SSD 7024 - St George Hospital Redevelopment Stage 2 – Acute Services Building

Notice of Exhibition

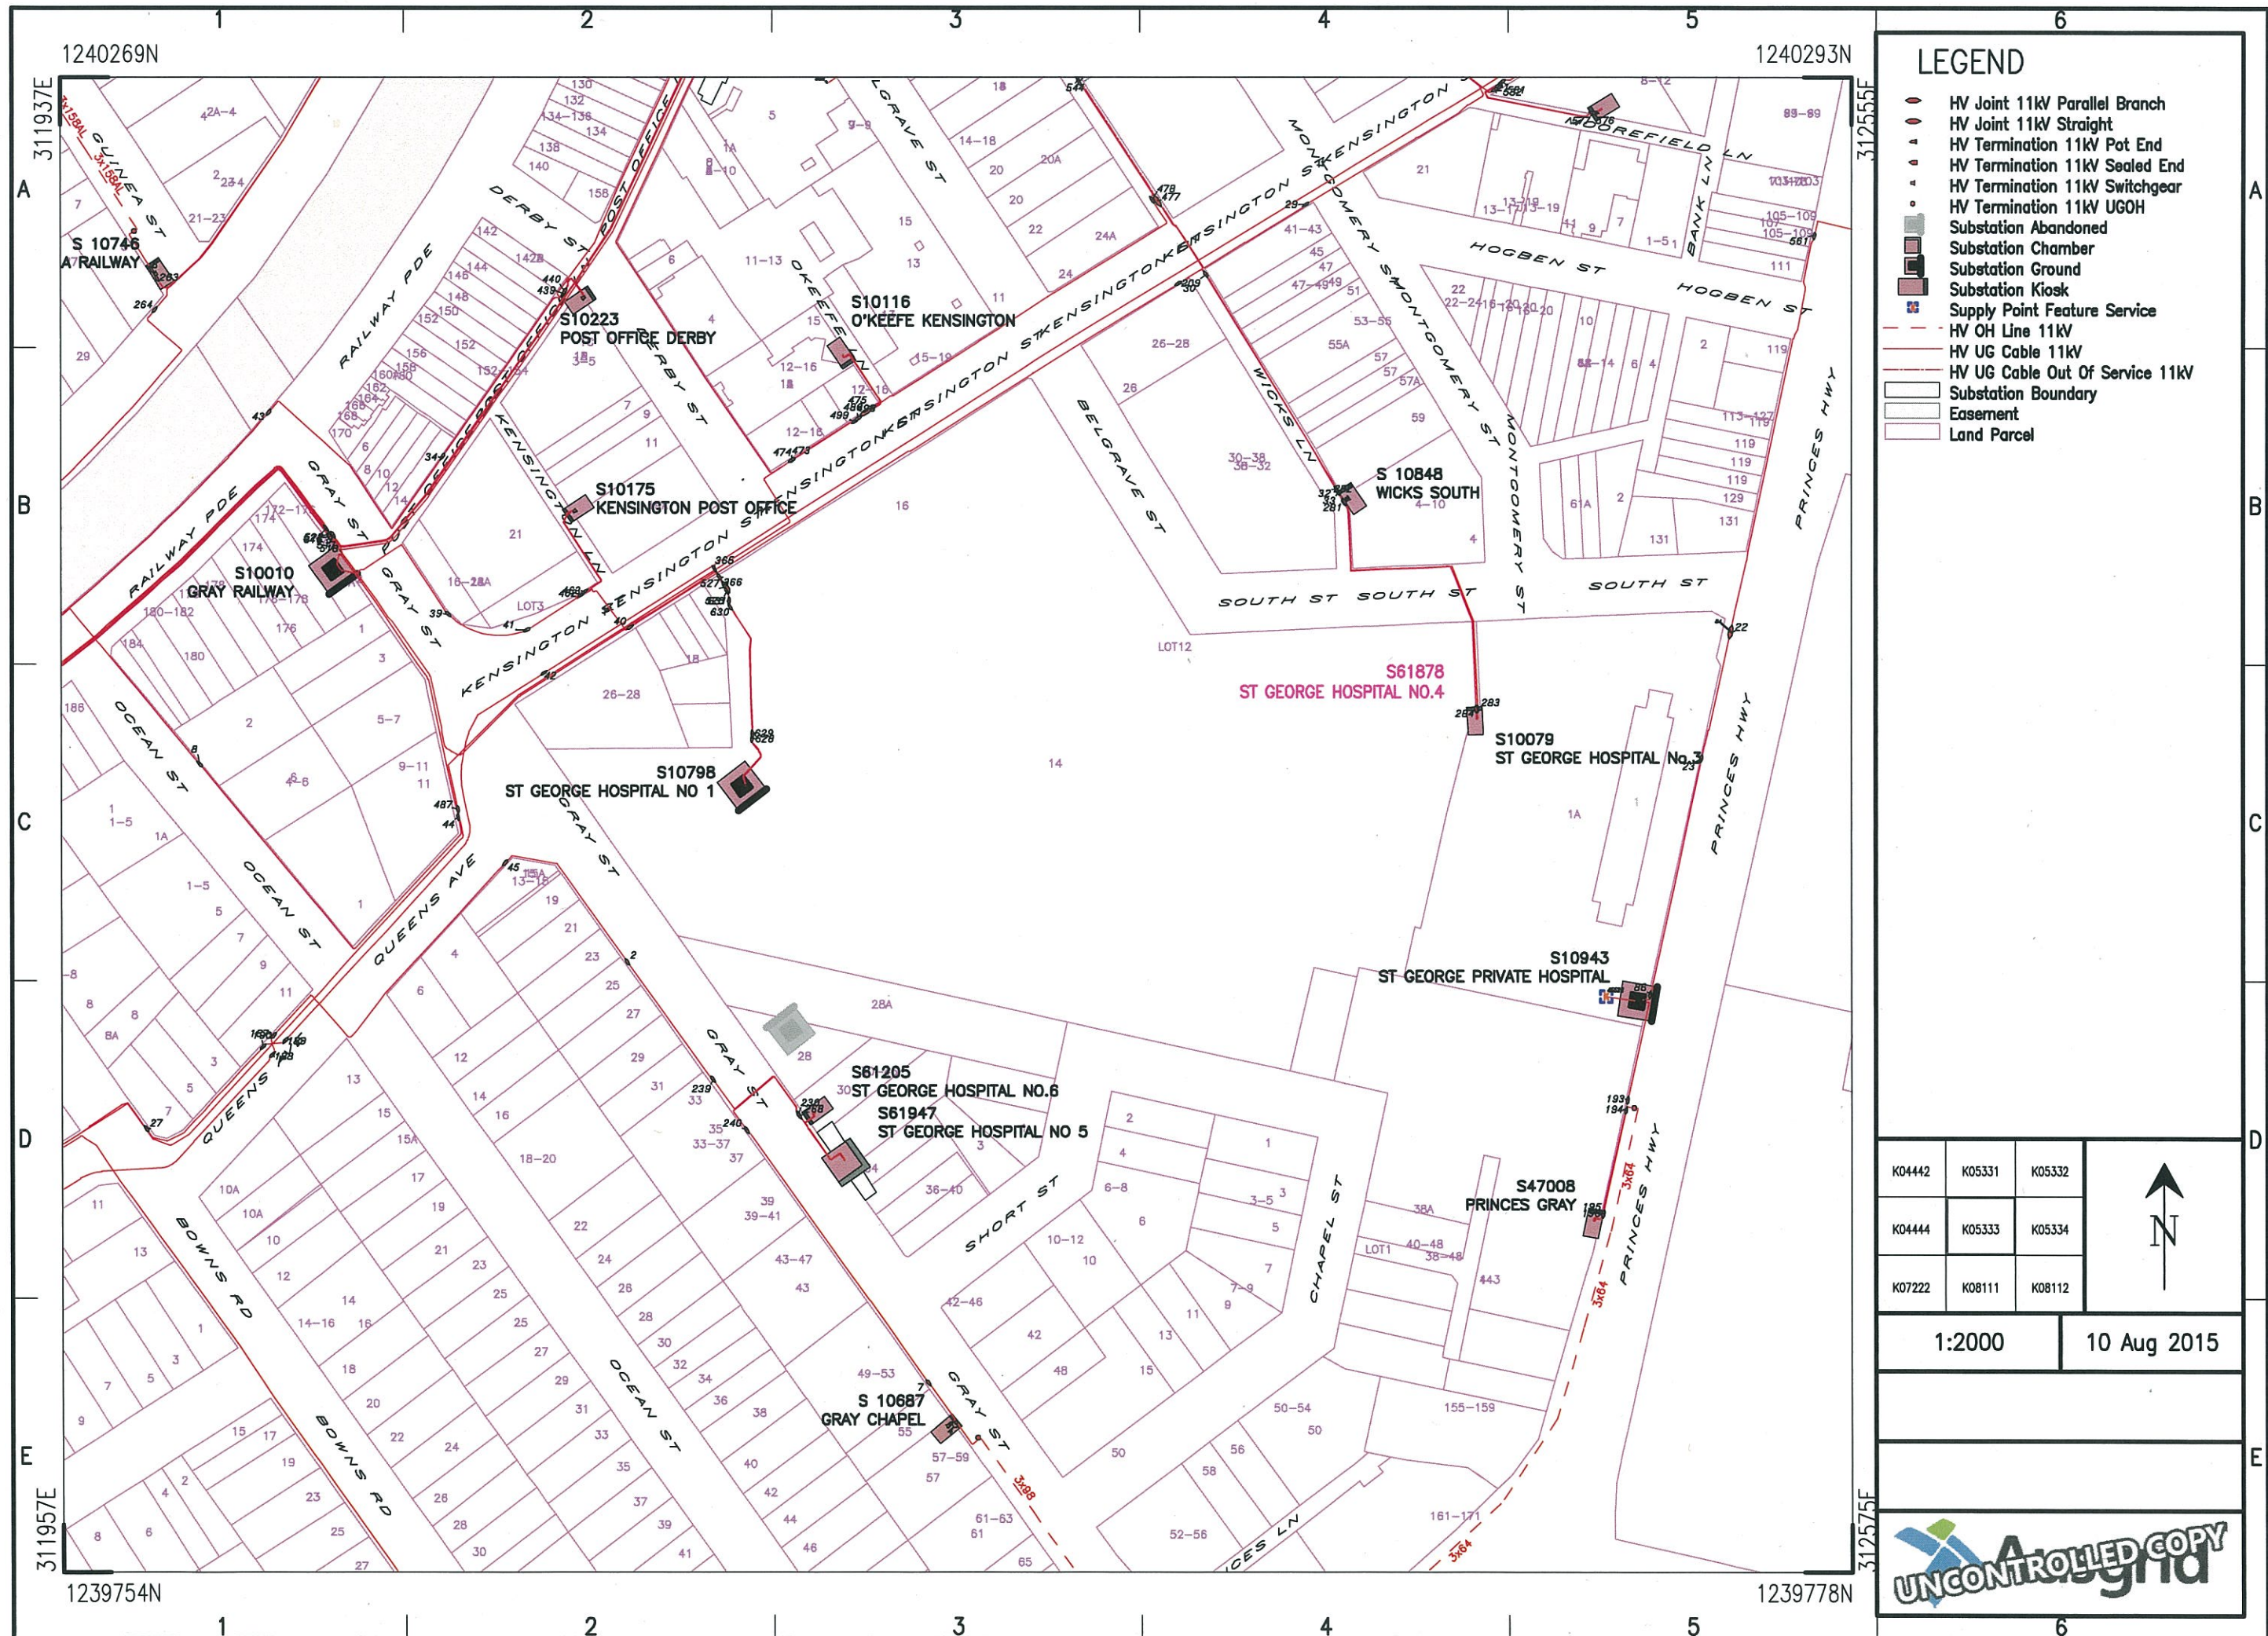
1. 11,000 cables and substation within the proposed development area, which will be impacted.
2. 132,000 volt cables and 33,000 volt gas pressurised cables, which reside in the vicinity of the proposed development. Whilst these may not be directly affected by the current proposal, it is anticipated that future carpark development along Kensington Street will impact these cables due to construction vibration.

We note you have identified that electrical substation works will be undertaken as part of the development. Ausgrid requires that the Department make it a condition of consent that Health Infrastructure (**Proponent**) consult with Ausgrid regarding the continued safe and secure supply to the hospital, and for any works necessary for the relocation of Ausgrid's infrastructure.
